## Board of Zoning Appeals Meeting November 21, 2023

CASE NUMBER: V-23-0014

PROPERTY LOCATION: 9630 Medlock Bridge Road, Johns Creek, GA 30097

VARIANCE REQUEST: To reduce the required parking spaces from 14 to 6.

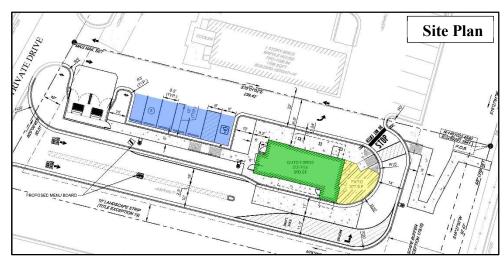
Furtunately, another drivethrough coffee company, Dutch Bros Coffee, proposing to construct a 950 square-foot drive-through coffee shop (shown in green), with a 377 square-foot outdoor patio (shown in yellow) and 6 parking spaces (shown in blue). Please note that there will be no inside dining associated with the building, as the principle drive-through is for use service.

To ensure adequate separation between multiple travel lanes adjacent to parking spaces, staff recommends a condition for appropriate stripping and signage to be provided to aid in internal traffic flow. Additionally, the proposed exit lane is shown on the site plan to encroach into the adjacent property to the north, and staff is recommending a condition for the Applicant to provide the City with a written approval from the adjacent property owner allowing for the proposed encroachment, prior to issuance of a Land Disturbance Permit.

- 1) The subject property shall provide a minimum of 6 on-site parking spaces as shown on the site plan received by the Community Development Department and date stamped on October 10, 2023.
- 2) Owner/Developer shall provide appropriate stripping and signage to aid internal traffic flow of vehicles for appropriate ingress/egress into the property and interaction with drive-through lanes, subject to the approval of the Community Development Director.
- 3) Owner/Developer shall provide written approval from the adjacent property owner to the north, approving the scope of work and encroachment on to their site, prior to the issuance of a Land Disturbance Permit.
